BLM Protest

Tru South, LLC
Change Application a50177
Water Right Nos. 81-4717 and 81-4887

January 10, 2024

Hydrogeologic Context

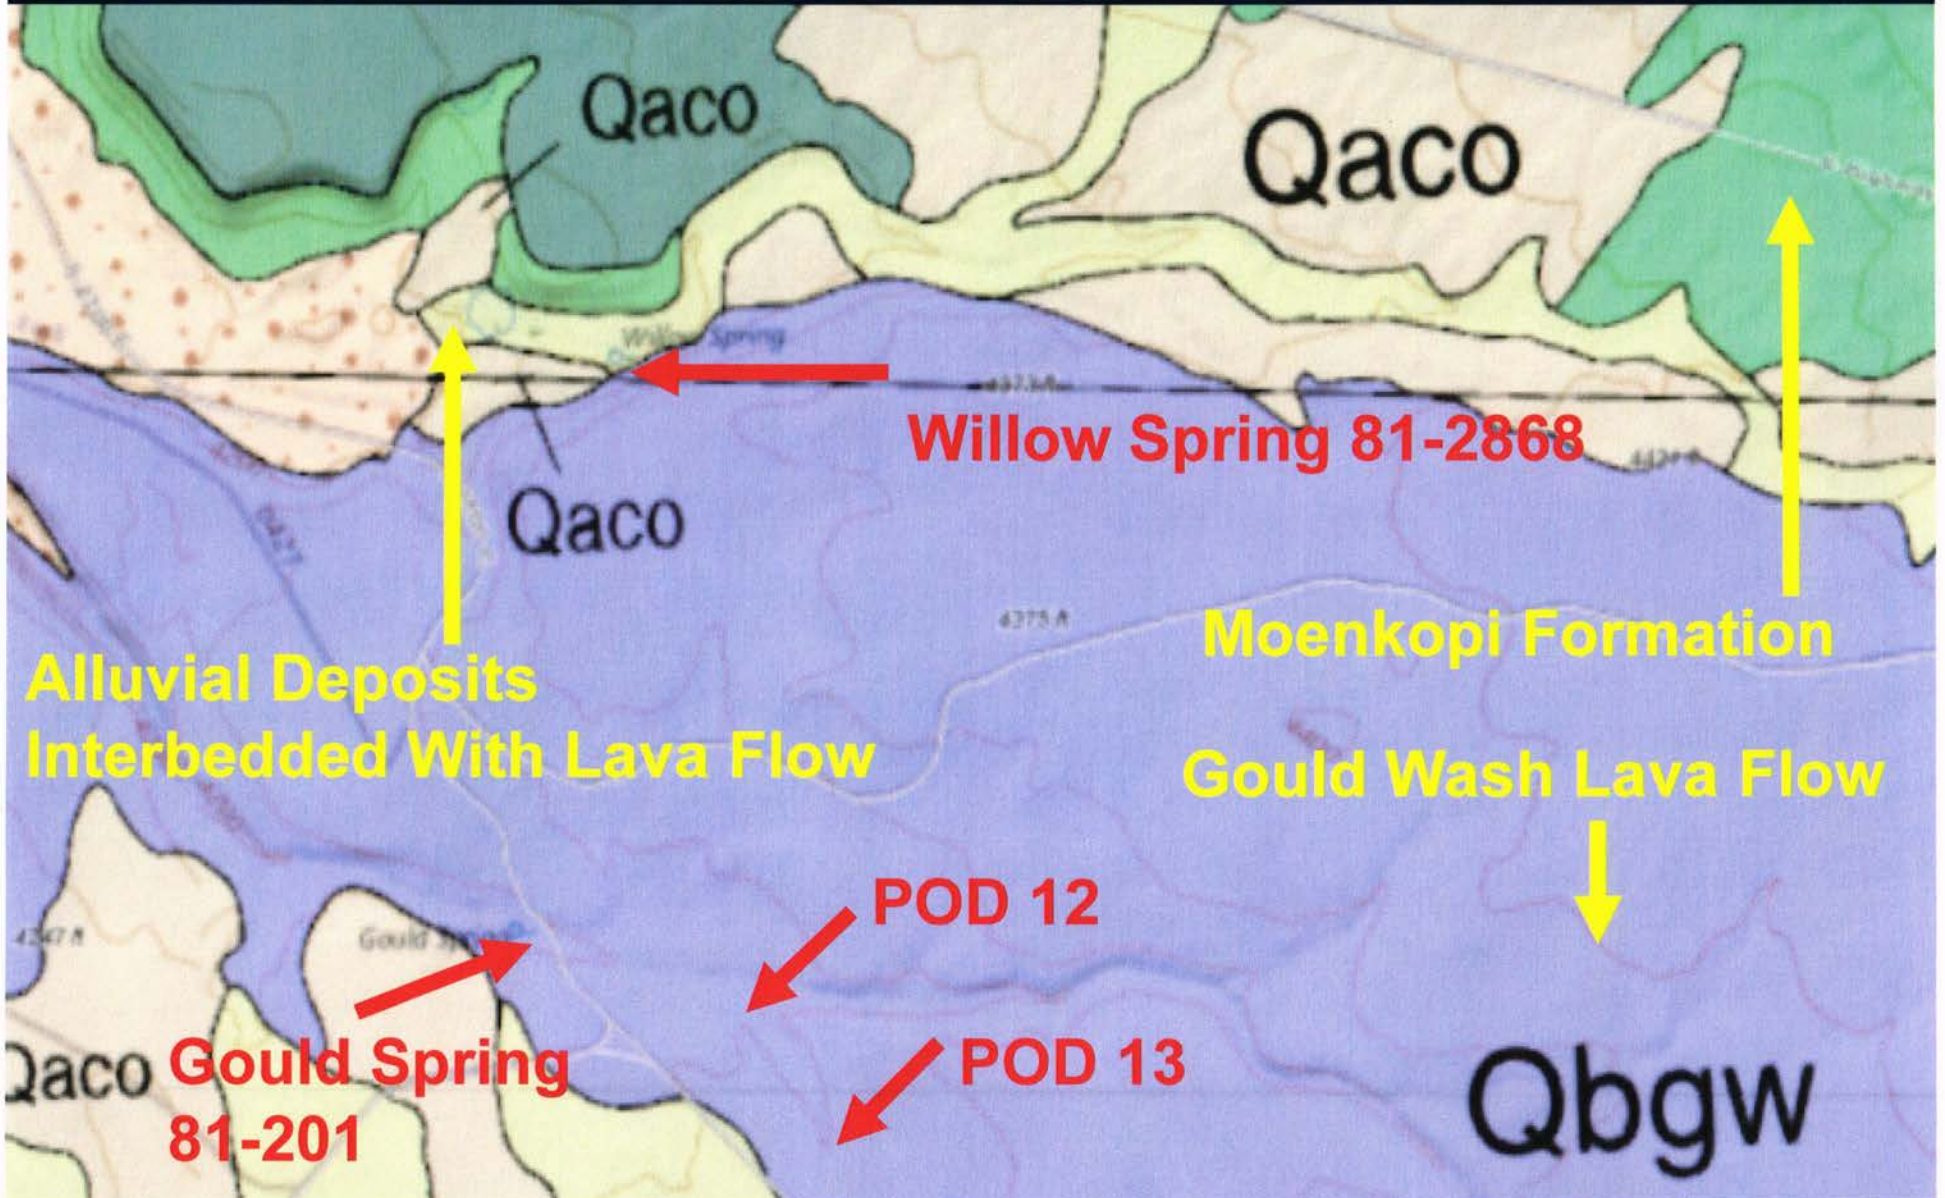
- In the protest document, BLM preliminarily concluded that the source of water for the springs may be the Moenkopi Formation. However, BLM's analysis has evolved after consultation with USGS.
- USGS analysis of previous studies/literature revealed that the less permeable Moenkopi Formation likely retards downward infiltration from overlying formations, resulting in significant groundwater storage in overlying formations. The overlying formations are the likely source of water for BLM's springs.

Hydrogeologic Context Oak Spring

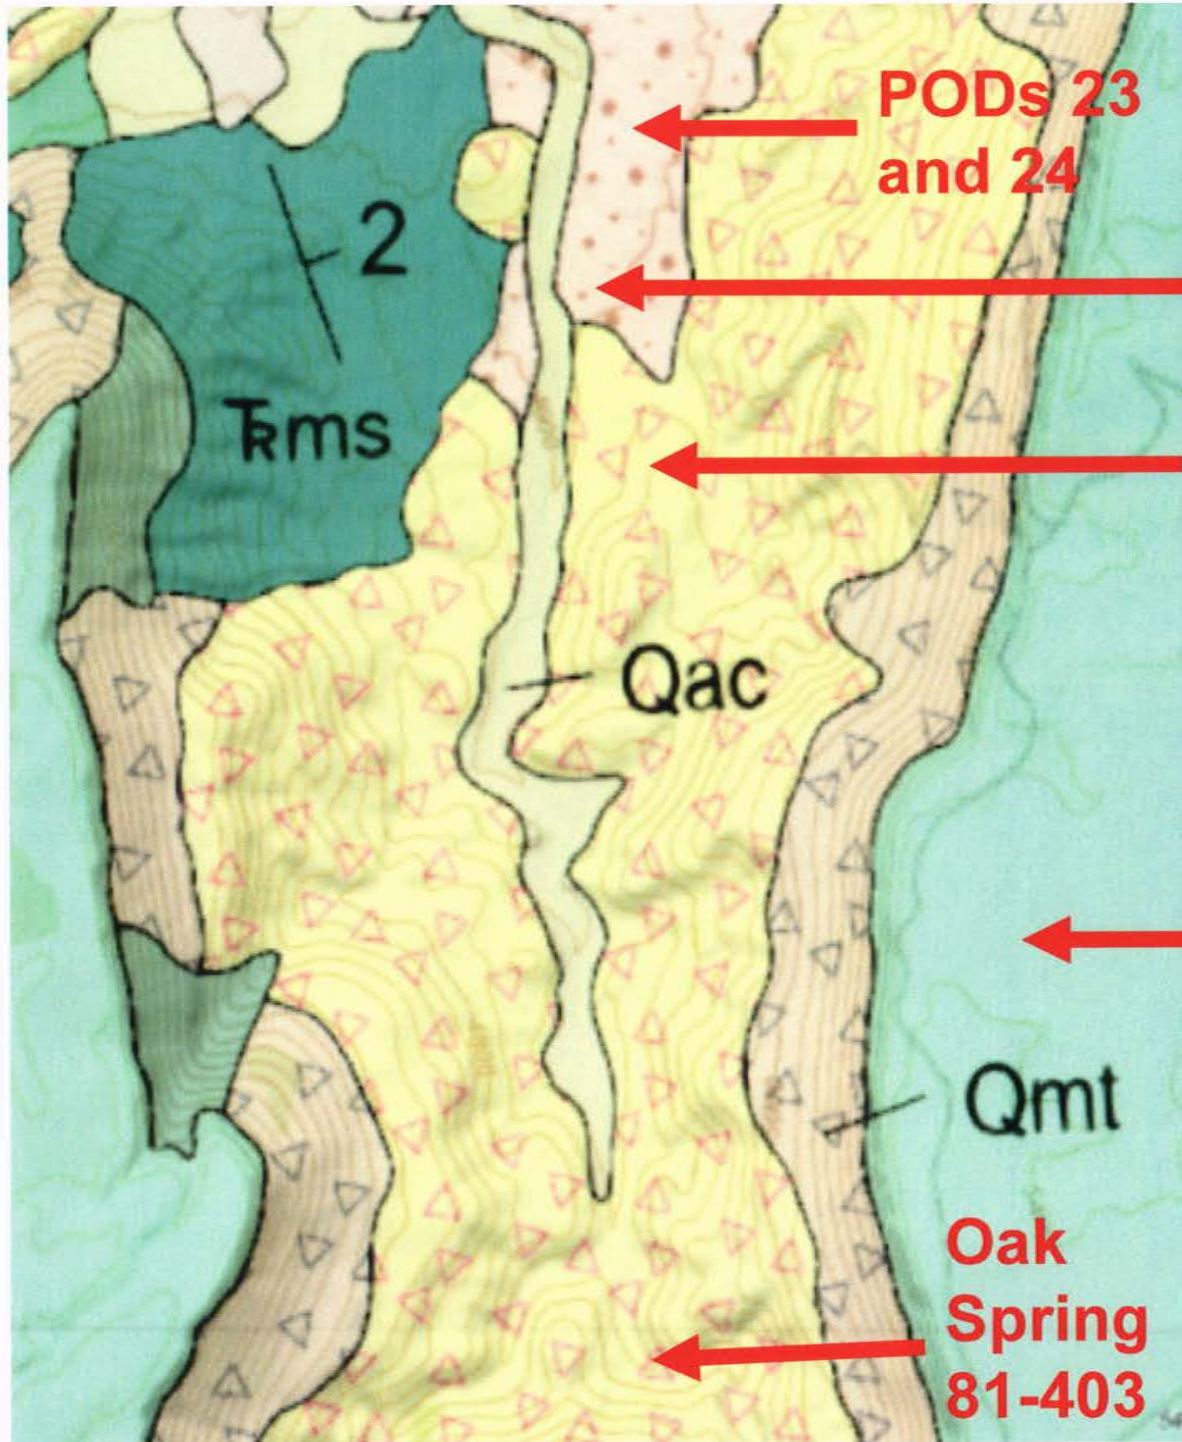
- Alluvial and landslide deposits overlying Shinarump Conglomerate have sufficient storage potential to serve as the water source.
- It is also possible that the Shinarump Conglomerate could serve as the water source, or discharge could be comprised of a mixture of discharge from overlying alluvial/landslide deposits and Shinarump Conglomerate.
